H12142

DESCRIPTIVE REPORT

Project OPR-O351-FA-09
Northern Glacier Bay, Alaska

Revisions and Corrections Compiled During Office Processing and Certification

Figure 2: Crossline and main scheme differences (white indicates agreement, warm colors indicate a XLs deeper than main scheme and cool colors indicate XLs are shallower).

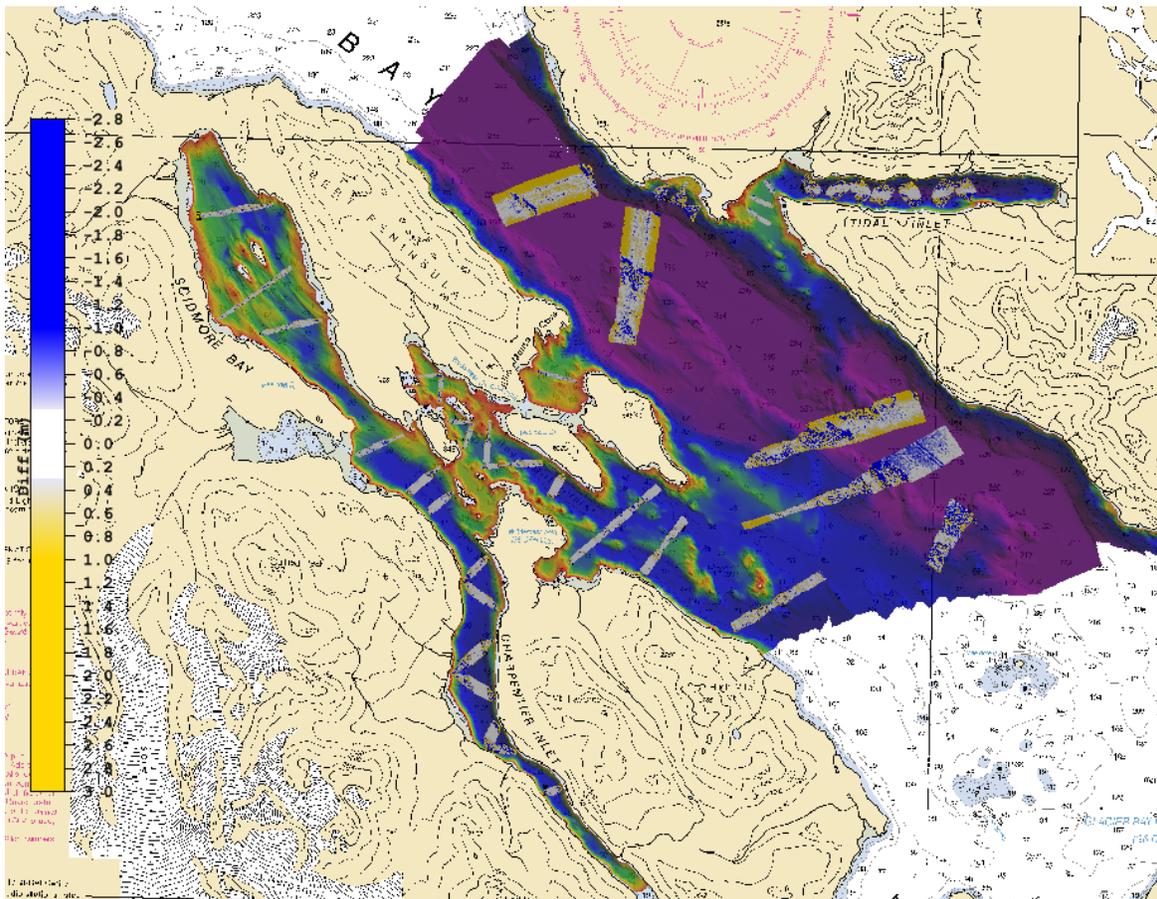
The most significant difference is approximately one meter in 60 meters of water. The issues that caused this were due to both a transducer offset and tide correction offset discussed in sections B.2.4.4. and B.2.4.5., respectively. Otherwise, in flat areas the crosslines show agreement within 0.3 meters.¹ Areas of disagreement are isolated to steeply sloping areas.² CARIS HIPS Subset Editor was also used to assess crossline/main scheme agreement and supports the results observed with surface differencing.

² Concur with clarification. Higher disagreement is expected in areas of steep slopes. The data has been inspected and deemed adequate for charting.

Figure 3: Junction between H12142 and H12141.

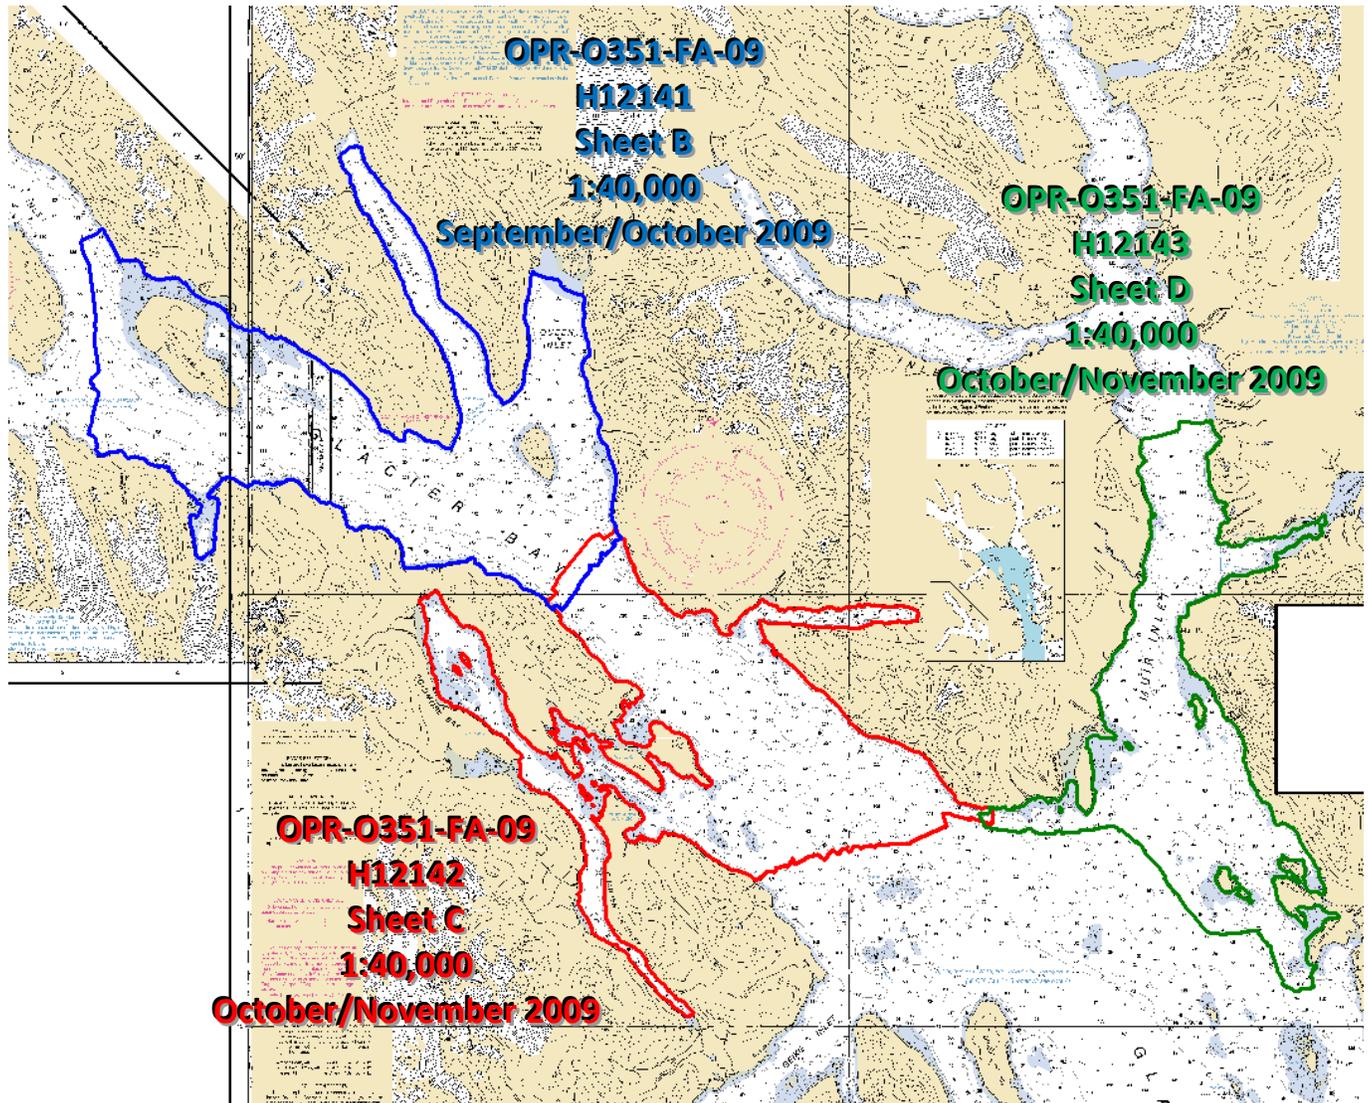
Survey H12142 junctions with H12141 and H12143, which are Sheet B and Sheet D respectively of the same project (Figure 3).³ The area of overlap between the surveys was reviewed in CARIS HIPS Subset Editor and in CARIS Bathy Database using surface differencing. The junction soundings and surfaces from H12141 and H12142 in the middle of the western arm of Glacier Bay in deep flat areas approximately 400-450 meters deep are in agreement within one meter.⁴ Significant vertical differences between surfaces upwards of 15 meters exist along the steeply sloping walls of the Bay due to slight horizontal positioning differences between the soundings contributing to the surfaces. The small area of overlap between H12143 and H12142 exhibits similar sounding and surface junction characteristics due to the steep slope of the wall.⁵

⁵ Concur with clarification. Higher disagreement is expected in areas of steep slopes. The data has been inspected and deemed adequate for charting.

Figure 4: Observed down slope holiday.

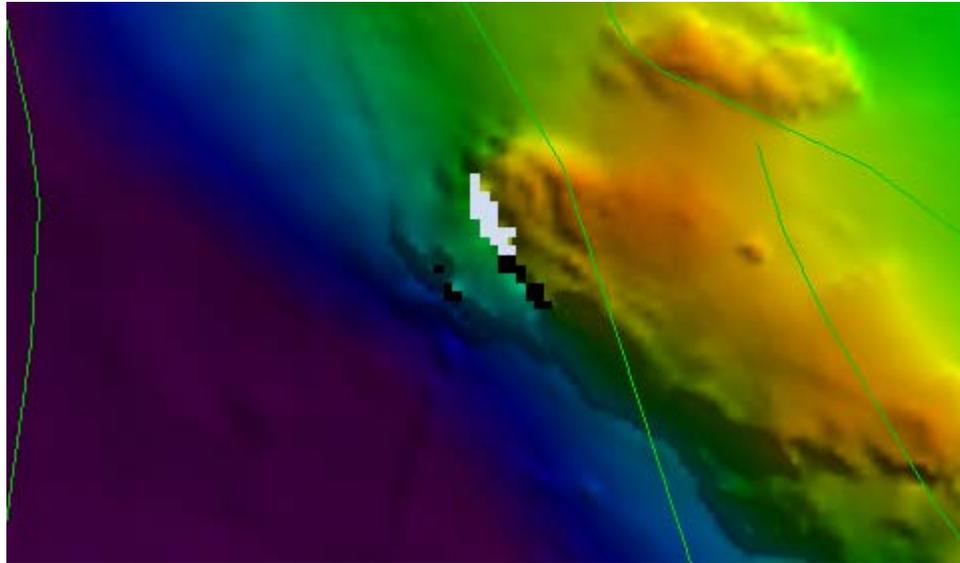
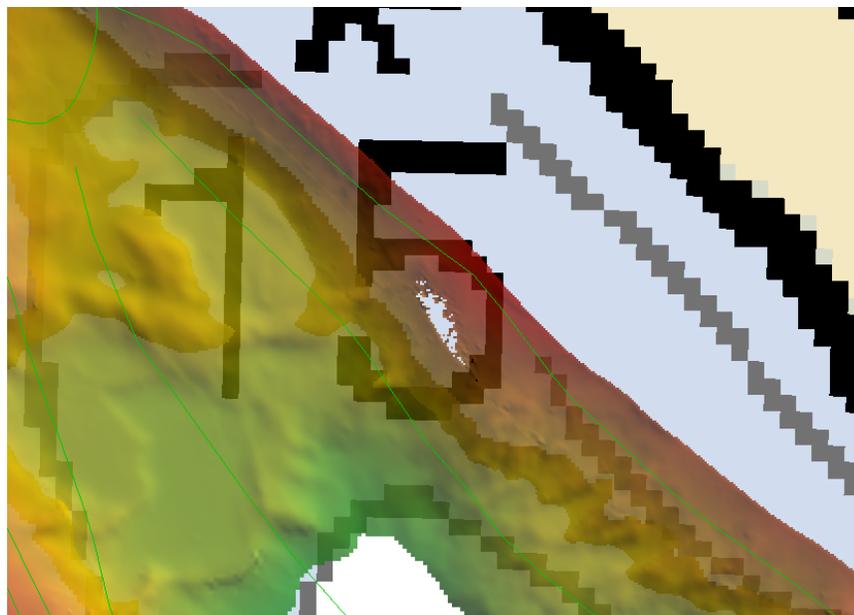
Two significant holidays exist within H12142: one in position 58° 45' 09" N, 136° 31' 39" W due to masking of a down slope rock (Figure 4), and a second in position 58° 46' 29" N, 136° 32' 08" W due to significant down slope noise (Figure 5).

⁶ Concur. The significant holidays identified were a result of rejecting down-slope noise and the least depths are represented in the data. The holidays were not preserved in the HCell coverage.

Figure 7: Offset between S220 Reson 7111 (purple) and vessels 2801 (orange) and 2802 (yellow).

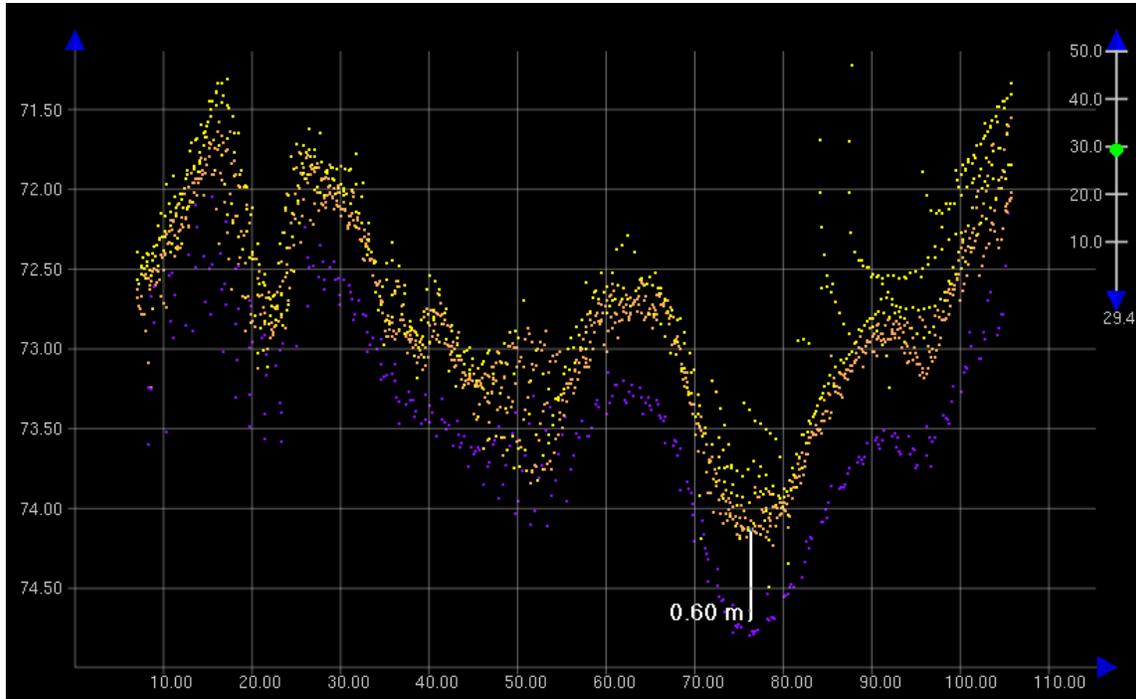
A systematic vertical bias exists in *Fairweather* (S220) Reson 7111 data biasing the data deeper by approximately 0.6 meters relative to other vessels in areas of overlapping data (Figure 7).

Figure 8: Delineation of Reson 7111 data out of IHO error specifications shown in red.

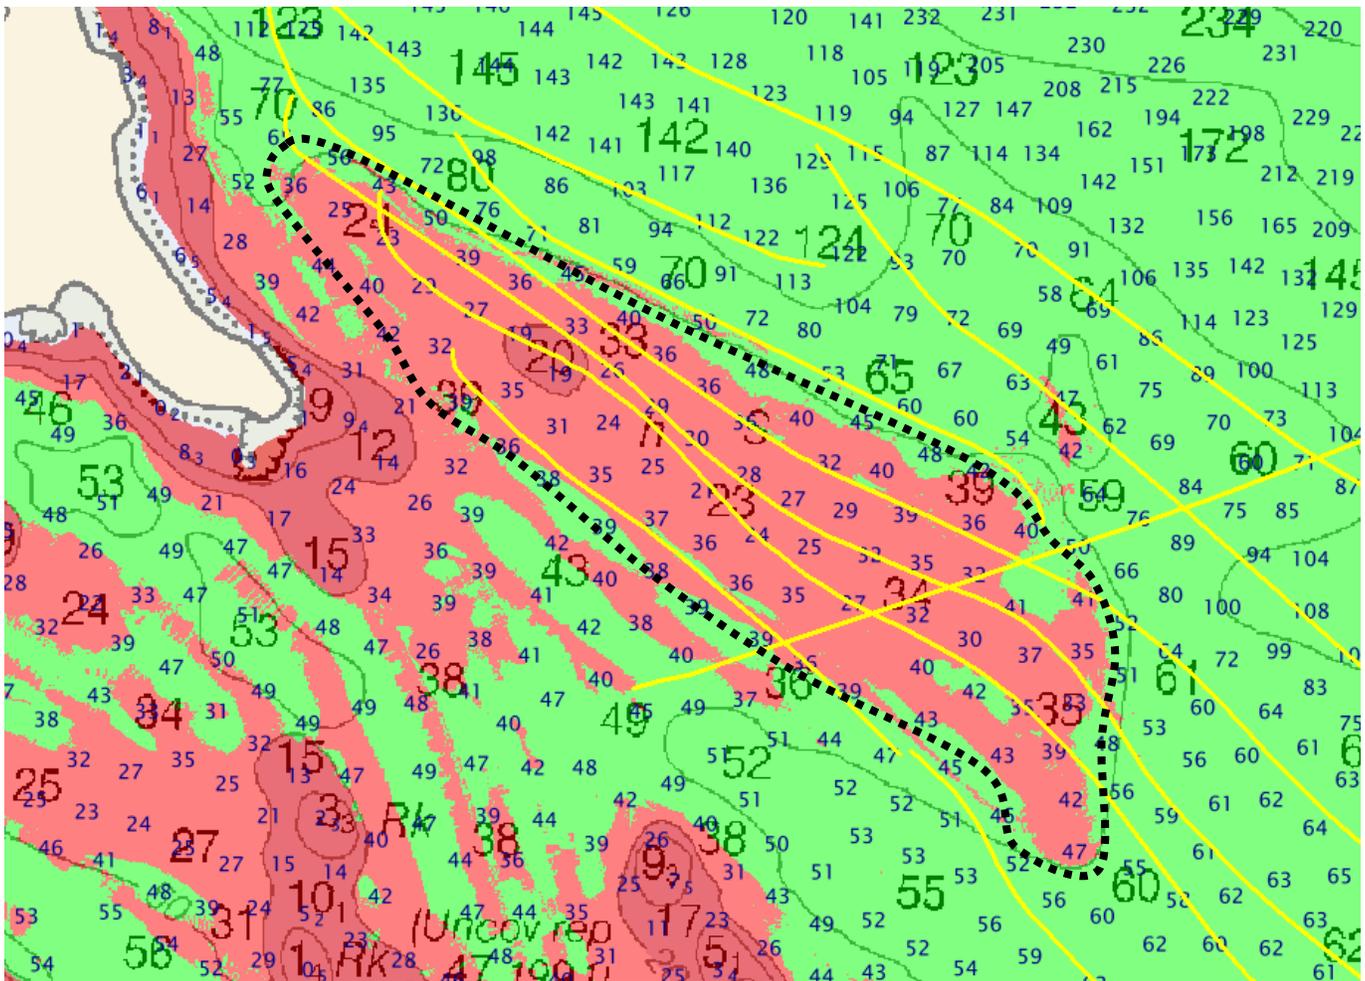
The area of Reson 7111 data that do not meet vertical accuracy standards is on the Southwest side of Glacier Bay, Southeast of an unnamed island that defines the Southeast extents of Blue Mouse Cove (Figure 8). The child layers shown in Figure 8 are colored red for values less than zero where the sum of the uncertainty and the bias is greater than the allowable error. Values greater than zero have been colored green. The tracklines of the Reson 7111 data are shown in yellow with an approximate delineation of the affected area as a dashed black line. Areas in the figure colored red that do not coincide with Reson 7111 tracklines were collected from different platforms and are not affected by the bias and should be disregarded in this analysis.

While these Reson 7111 data in the delineated area do not meet accuracy requirements they do meet coverage requirements and are shoaler than charted soundings. The Hydrographer recommends that they be used to supercede the chart.¹⁰

¹⁰ Concur. Since the depths are shoaler, and therefore more conservative, than what is currently charted and full coverage was achieved, the data should be used to supersede charted depths in the common area.

Figure 9: Comparison of Zoned Tides based on Gauges Juneau and Composite Island.

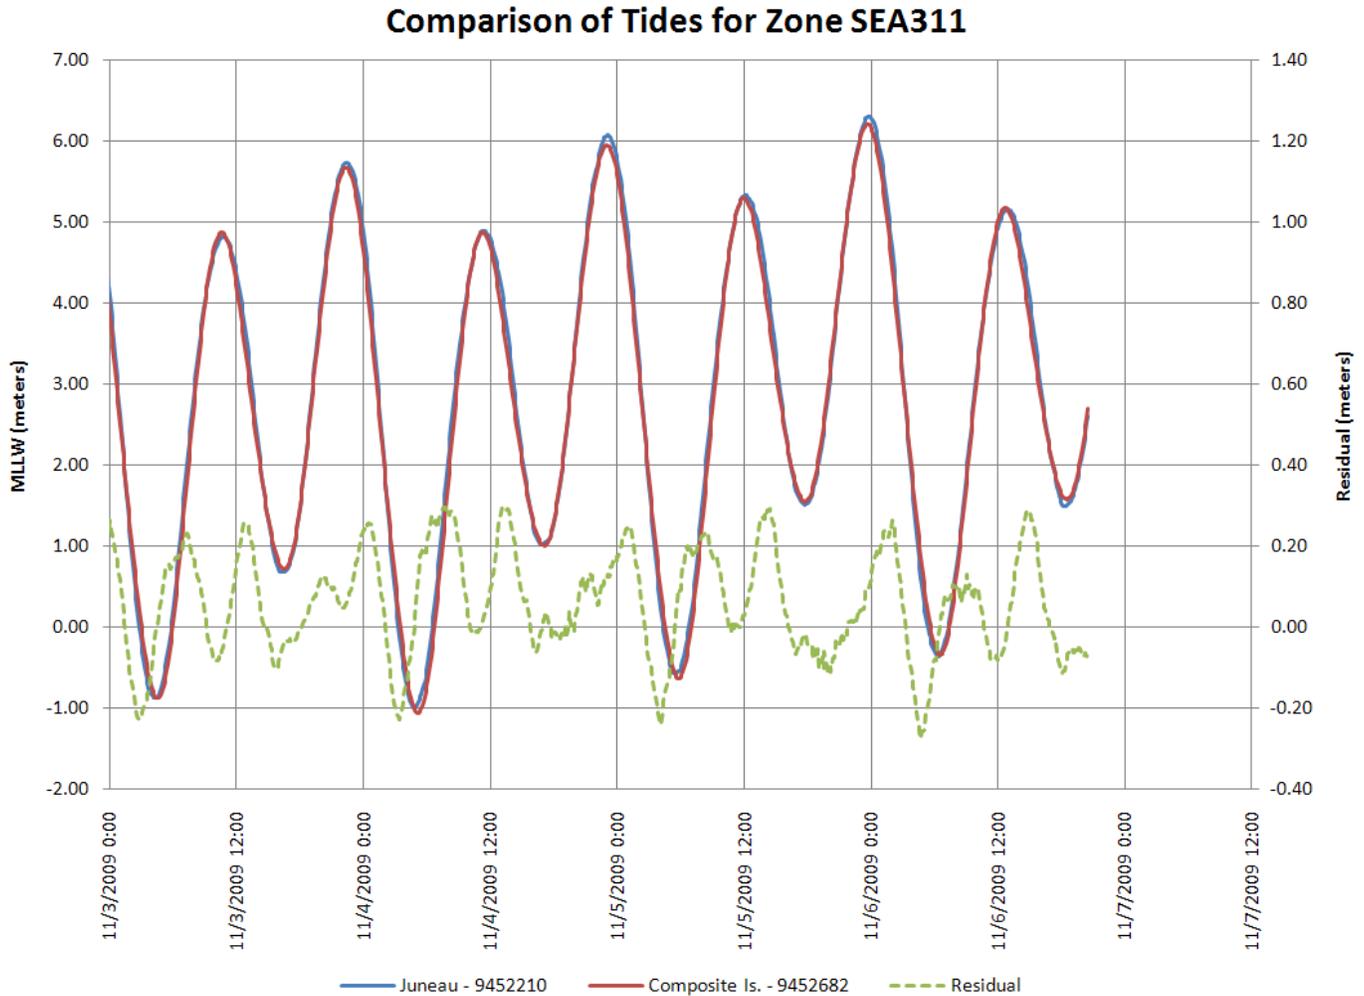
To identify the differences in residuals between the project area and the Juneau gauge a comparison was made of the zoned tides between Juneau and Composite Island for four days prior to the removal of Composite Island (Figure 9). The comparison shows a difference in residuals of +/- 0.3 meters peaking at the ebb and flood of the tide. As the data were collected by launches 2801 and 2802 on DN 314 during an

As the bias is less than the minimum IHO Order 1 allowable error it is still within specification.¹¹ Additionally it should be noted that the bias causes a shoaling of depths relative to unaffected data and the data should be used to supercede the chart.¹²

¹² Concur.

Figure 12: Extent of Charpentier Inlet.

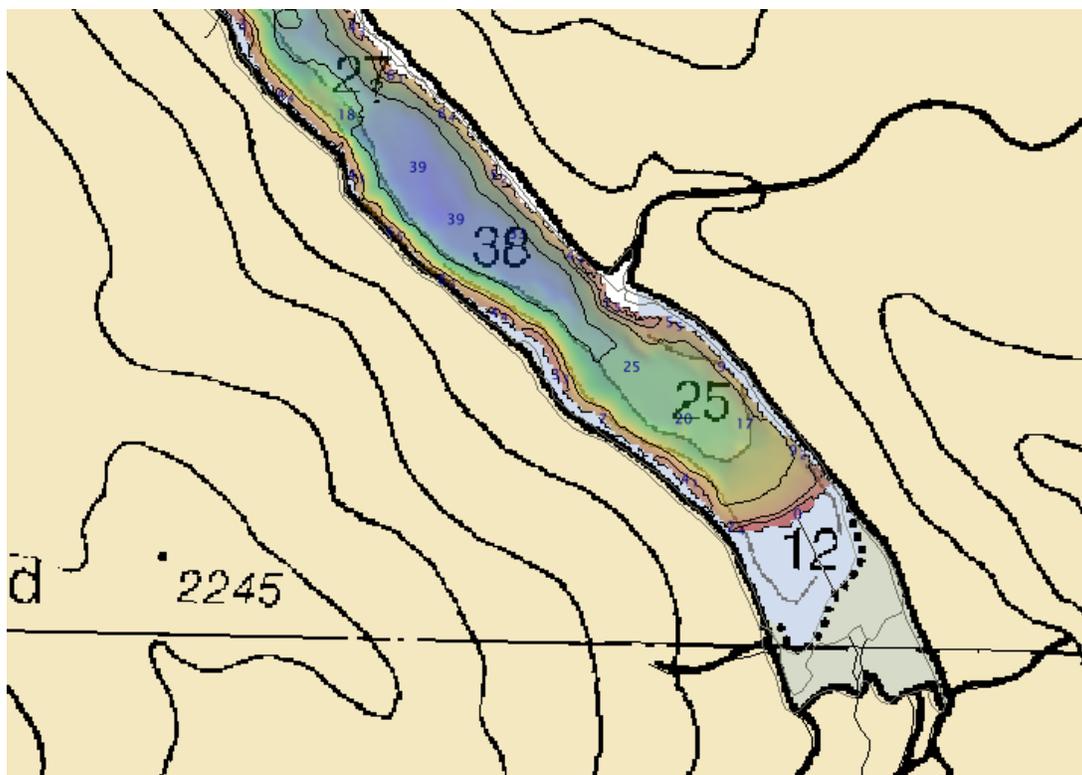
The deepest section of the main basin of Glacier Bay is consistently 3-5 fathoms shoaler than charted. At the entrance to Tidal Inlet two shoals were found to be approximately five fathoms shoaler than charted (Figure 10). A shoal East of the entrance to Hugh Miller Inlet was found to be four fathoms shoaler than charted (Figure 11).²⁴ At the Southeast termination of Chapentier Inlet the shoreline has shifted approximately 280 meters Northwest (Figure 12).²⁵

²⁵ Concur. Update the coastline with the latest GC source.
